DESIGN CHANGES

Project	COUNTY FLATS, SANDFIELDS
Project number	N297/2
Client	HALE CONSTRUCTION LTD
Title	BLOCK 01/02 ELEVATIONS 1/2
Drawing number	A011A
Scale	1 : 100 at A1
Revision	I
Status	INFORMATION
Drawn	PC
Date	30.11.21

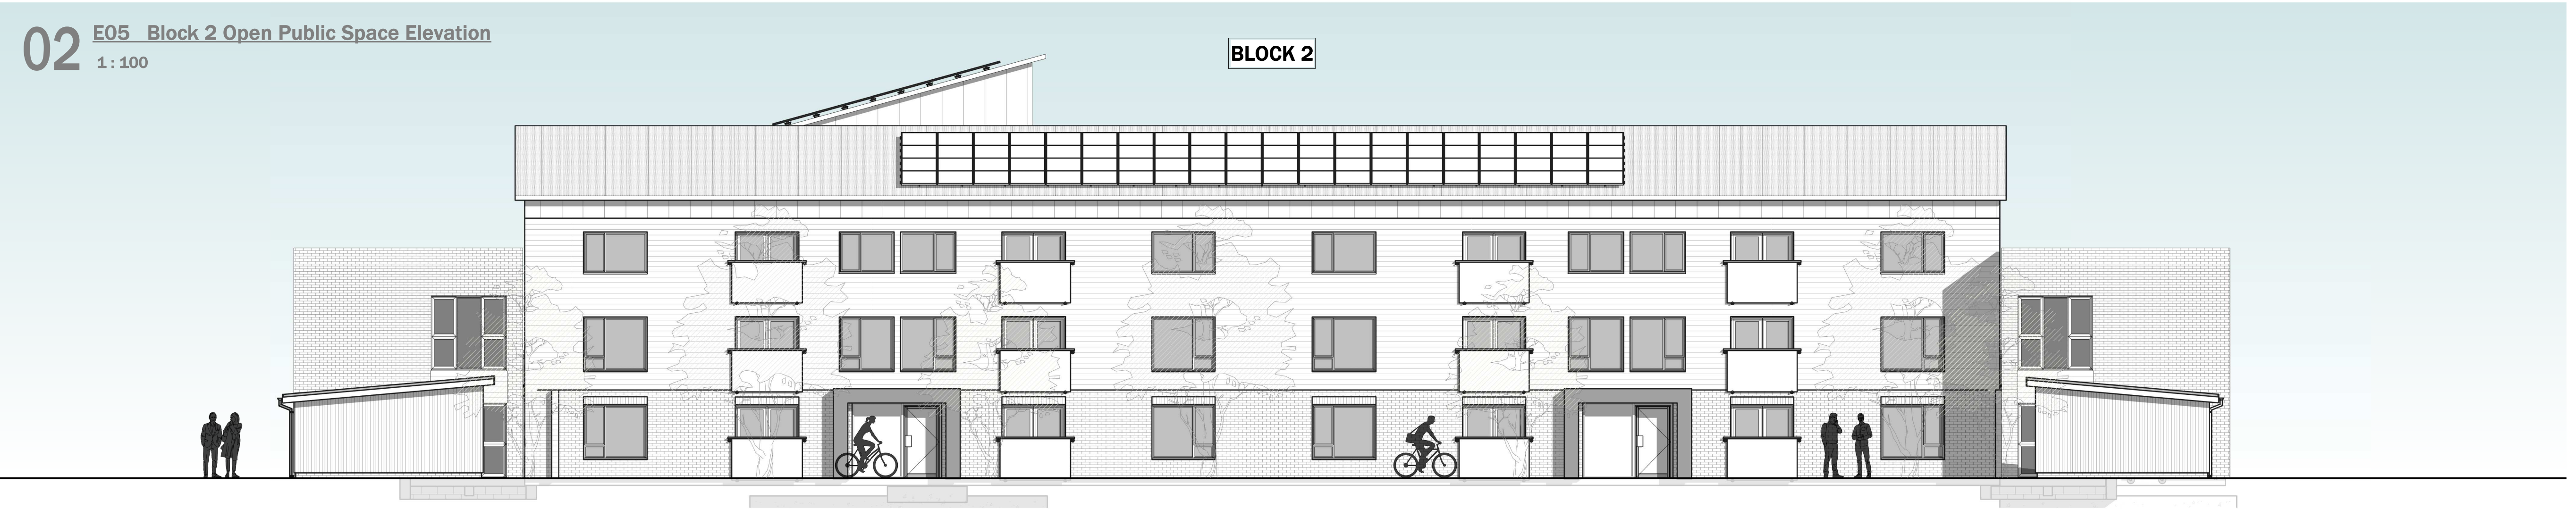
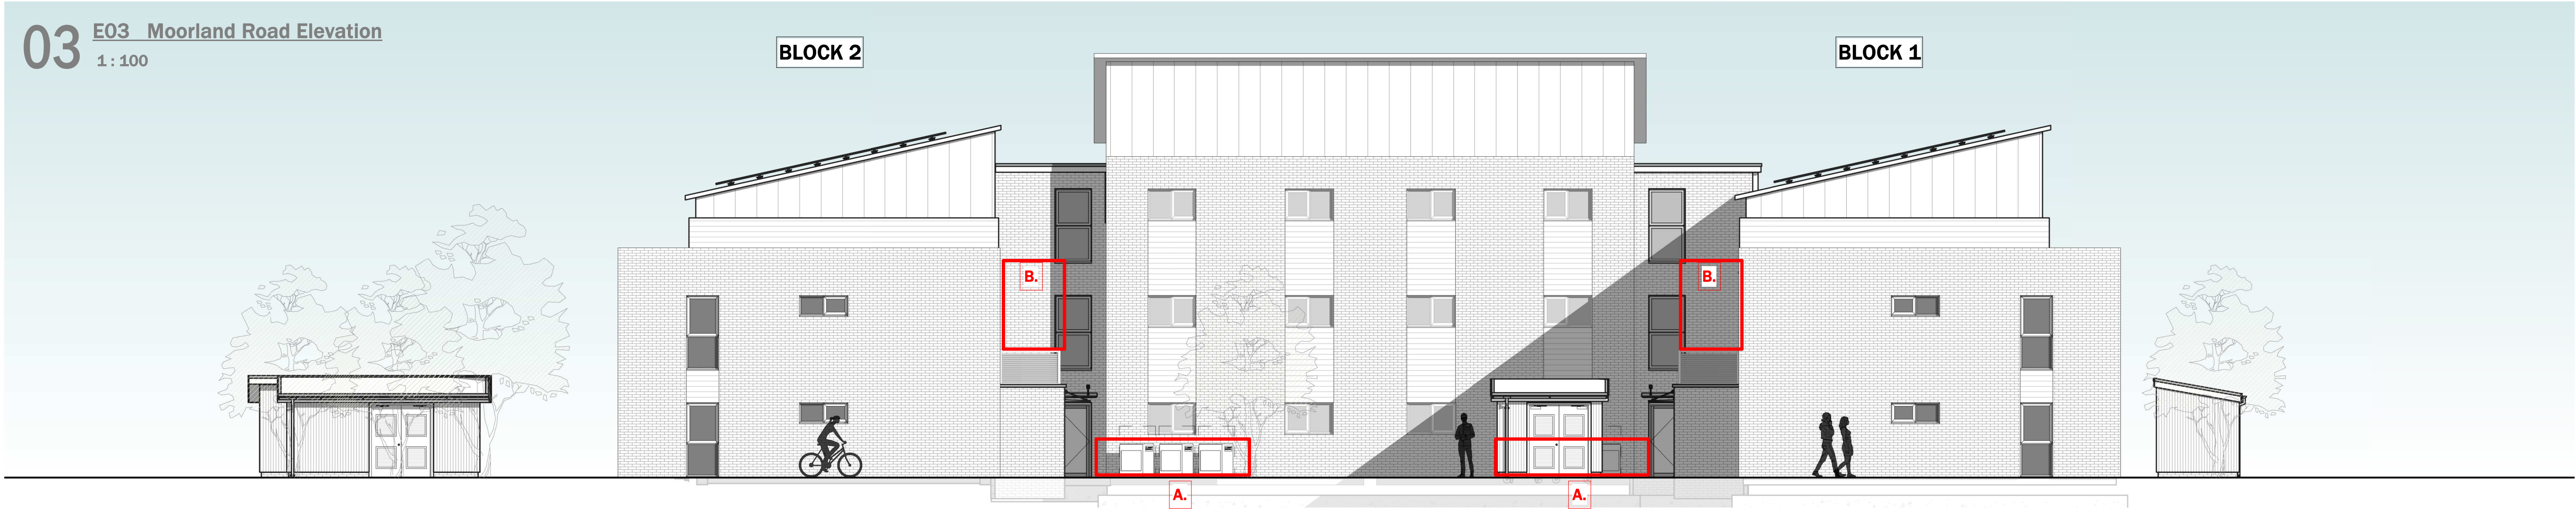
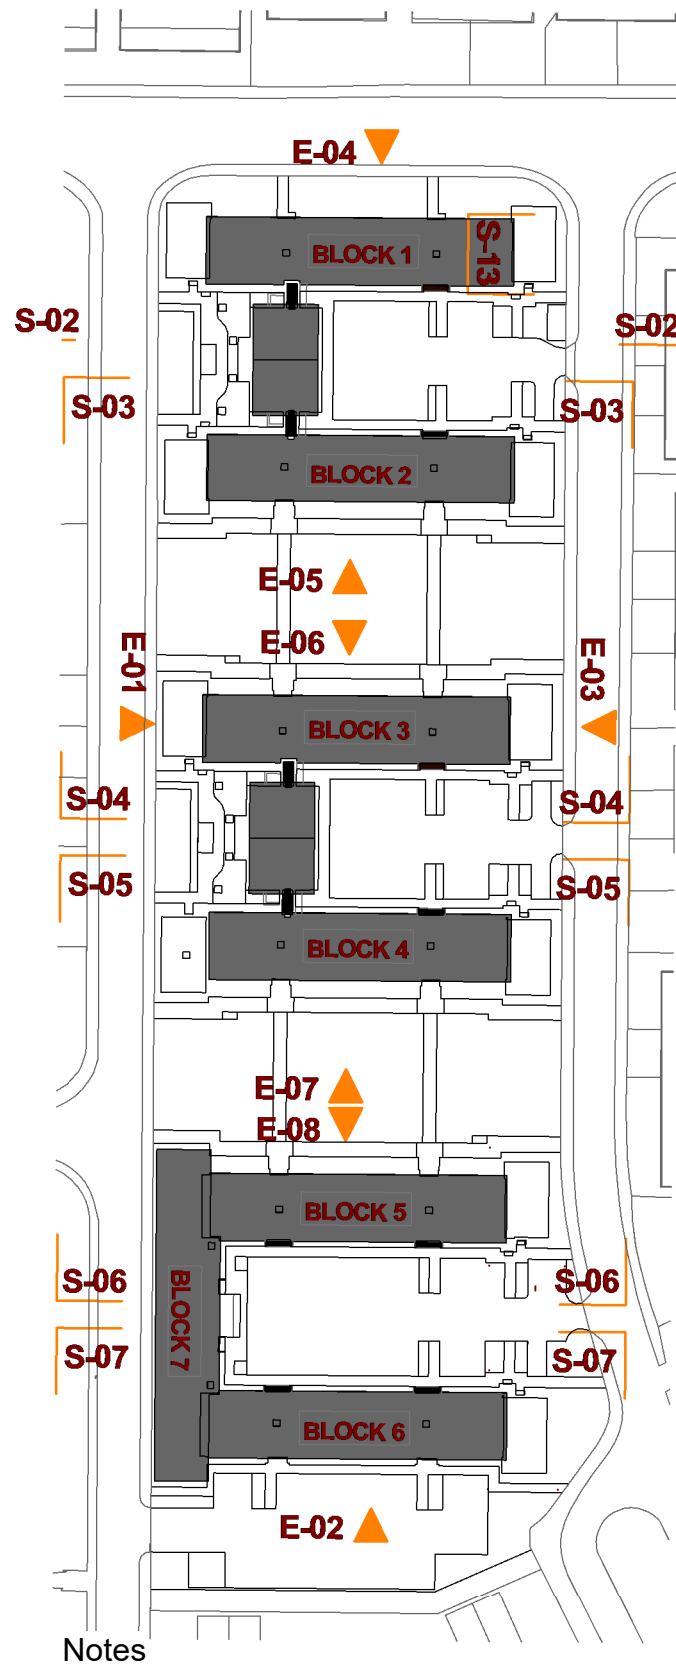
A. LOUVRED ENCLOSURE REMOVED FROM LINK BLOCK AND AIR SOURCE HEAT PUMP UNITS RE-LOCATED ONTO GROUND FLOOR, TO REAR PARKING COURTYARD

B. LOUVRED ENCLOSURE HEIGHT REDUCED TO APPROX 1M OVER PORCH ENTRANCE AND MADE WIDER TO MATCH PORCH WIDTH
